Rio Grande LNG Project
Final Environmental Impact Statement
Volume III, Part 3

Rio Grande LNG, LLC and Rio Bravo Pipeline Company, LLC

April 2019
Docket Nos. CP16-454-000, CP16-455-000
FERC/EIS-0287F

CO (Companies and Organizations)

Terminal Site Demographics: Minority Population (Source: EJScreen mapping tool)

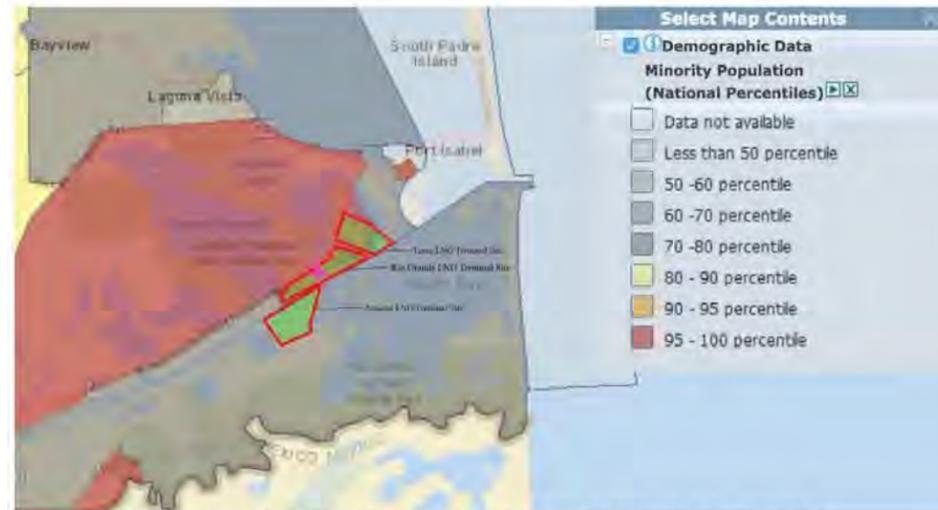
B. The DEIS Fails to Adequately Consider the Environmental Justice Impacts of the Rio Grande LNG Project

1. The Rio Grande LNG Project Will Have Adverse Impacts on Low-Income and Minority Communities

The neighborhoods in the area affected by the LNG facility Project are majority minority and low-income communities.¹⁵ The DEIS notes that the blocks closest to the LNG Terminal are "environmental justice populations."¹⁶ Cameron County is a majority-minority county, with non-

DEIS, Figure 4.9.3-1.

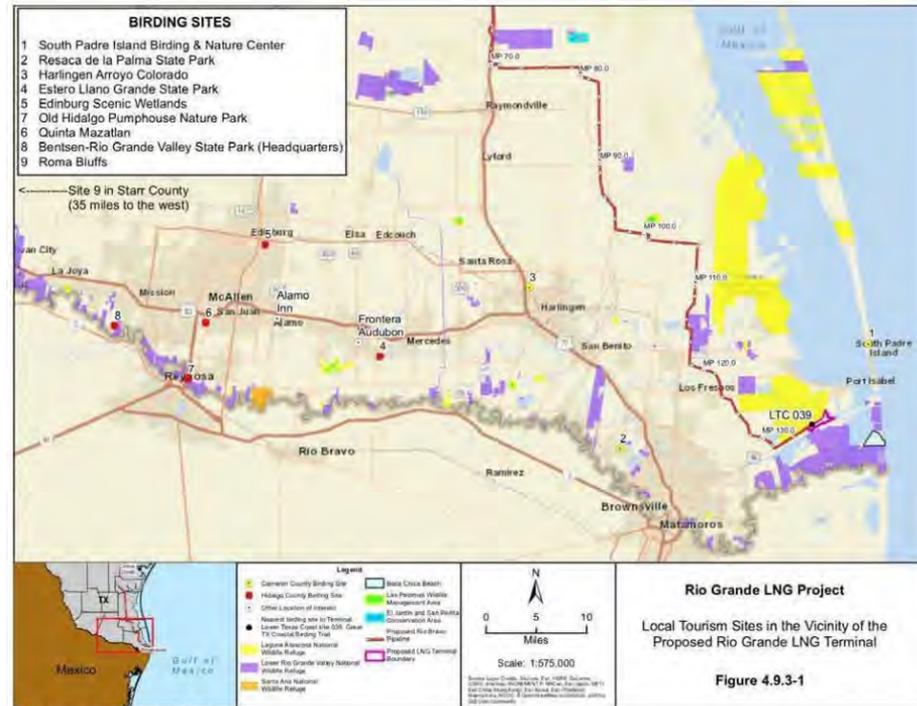
⁷¹ See DEIS, Figure 4.9.3-1 reproduced above.
